APPLICATION FOR DISPOSAL WORKS CONSTRUCTION PERMIT

TRI-LEVEL SALTBOX
SPECIFICATION & DESIGN
CHANGES

TRI-LEVEL SALTBOX - S1B62

RESIDENCE FOR: STEPHEN P. KIRITSY
AMHERST, MA.

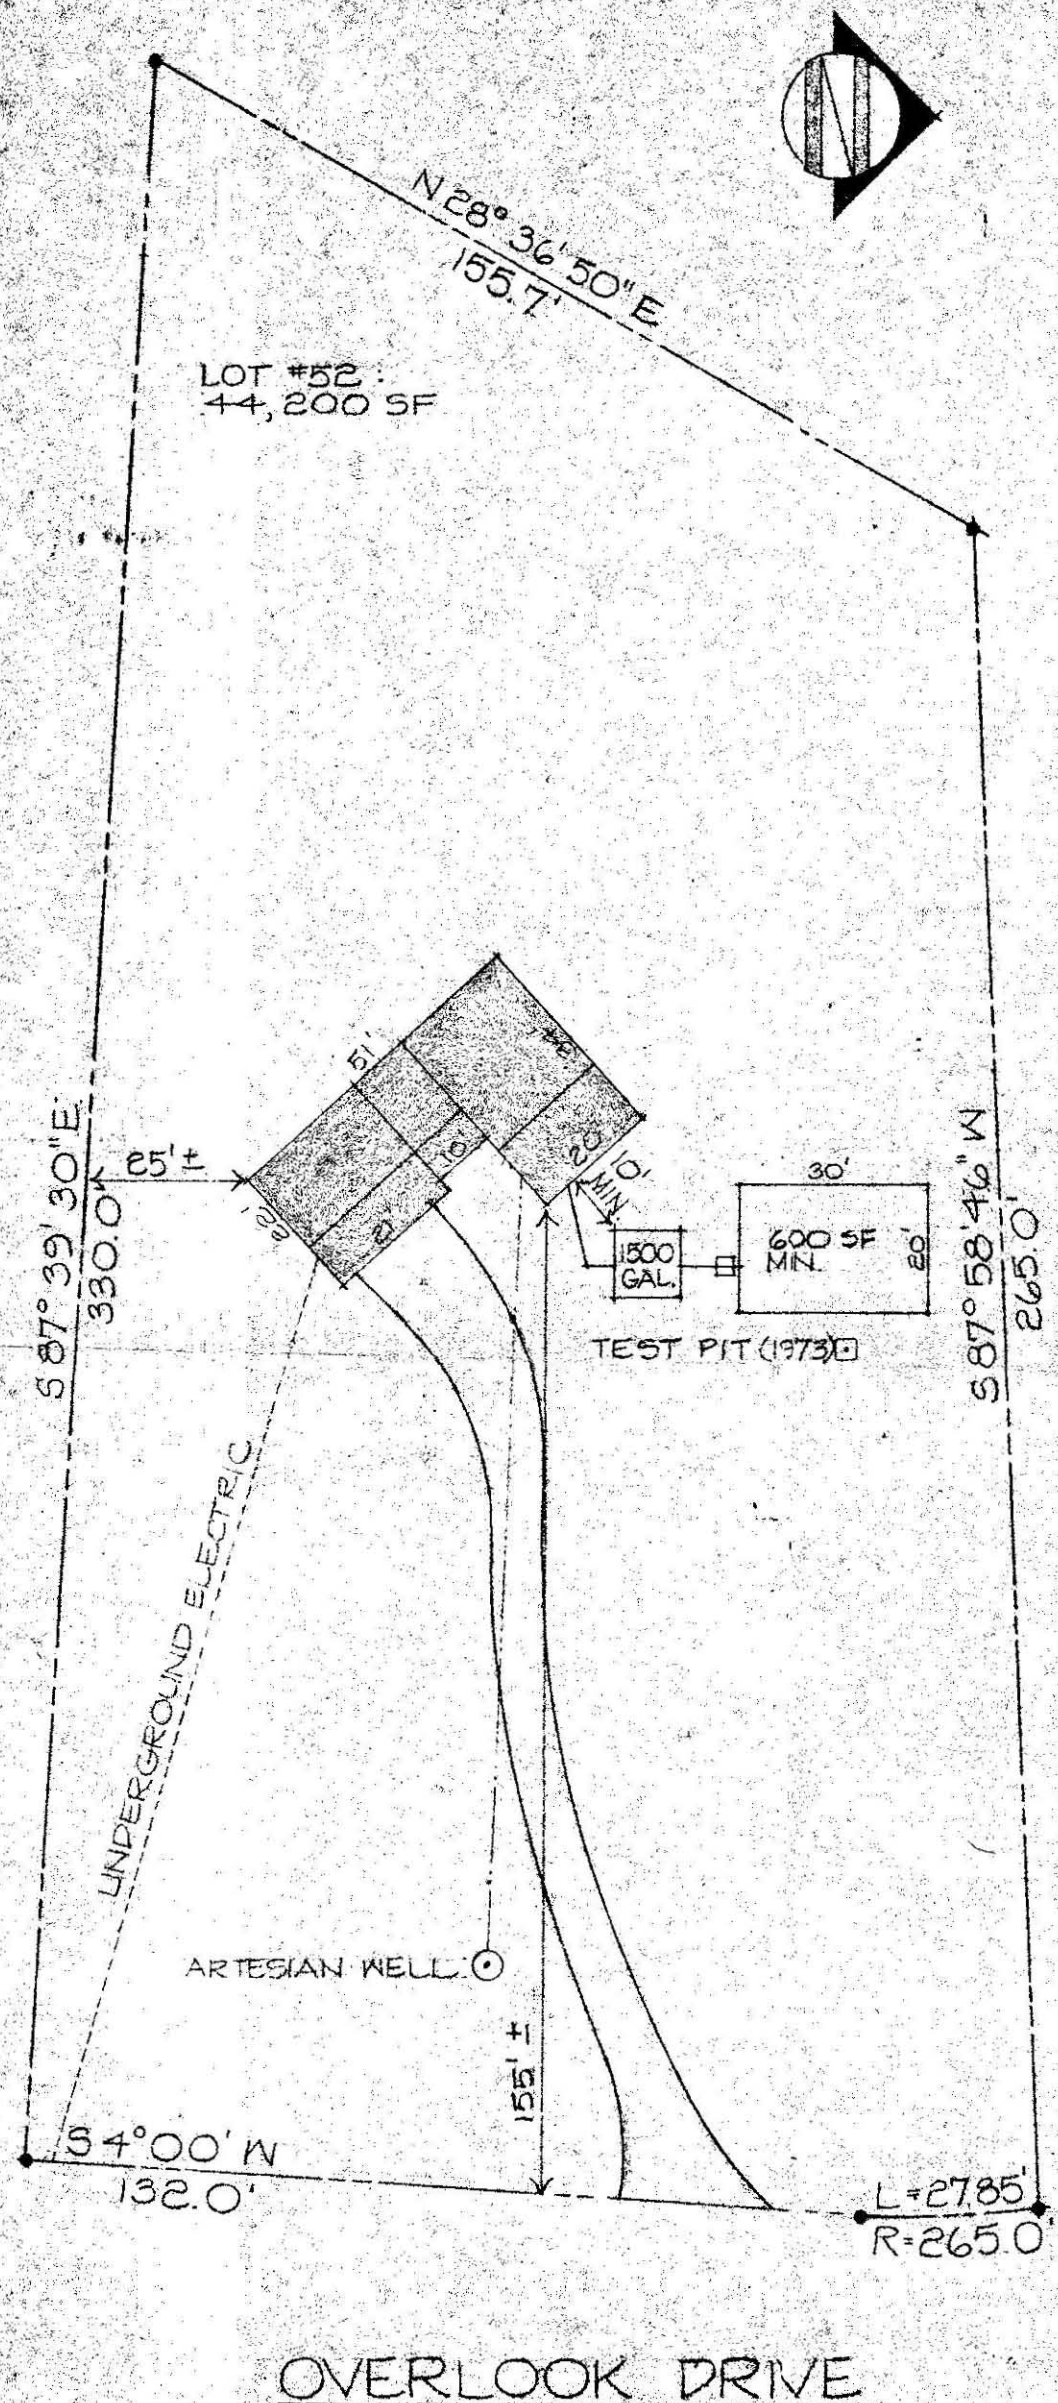
1. ENTIRE PLAN TO BE CONSTRUCTED IN REVERSE (MIRROR IMAGE) OF THE ORIGINAL PLAN.
2. BREEZEWAY TO BE ENLARGED TO 10' IN WIDTH & TO BE ENCLOSED USING SAME MATERIALS & CONSTRUCTION METHODS. 8' WOOD SLIDING GLASS DOOR TO BE INSTALLED ON SOUTH SIDE & 2'-8" STEEL DOOR TO BE INSTALLED ON NORTH SIDE.

3. GARAGE WALL ADJOINING BREEZEWAY TO BE COVERED WITH 5/8" SHEETROCK ON GARAGE SIDE & 2'-8" STEEL DOOR TO BE INSTALLED.
4. GARAGE SIZE TO BE INCREASED TO A 21'-0" x 22'-0" FOUNDATION SIZE W/ 2 GARAGE DOORS & ALL OTHER CONSTRUCTION DETAILS TO REMAIN THE SAME.

5. LIVING ROOM CEILING (CATHEDRAL) TO HAVE 2 SKYLIGHTS APPROX. 16" x 36" (INSULATED).
6. SOUTH WALL OF LIVING ROOM TO HAVE 2 FIXED PICTURE UNITS (INSULATED) R.O. 5'-10 1/8" x 4'-9 1/4" INSTEAD OF WINDOW B.

7. WOOD DECK 10'-0" x 14'-0" TO BE CONSTRUCTED ON SOUTH SIDE OF HOUSE OFF OF BREEZEWAY SLIDER W/ 3'-0" RAILINGS & WOOD STEPS.
8. DOWNSTAIRS BATH TO BE ENLARGED TO INCLUDE 28" x 48" FIBERGLASS SHOWER (SEE DETAIL).
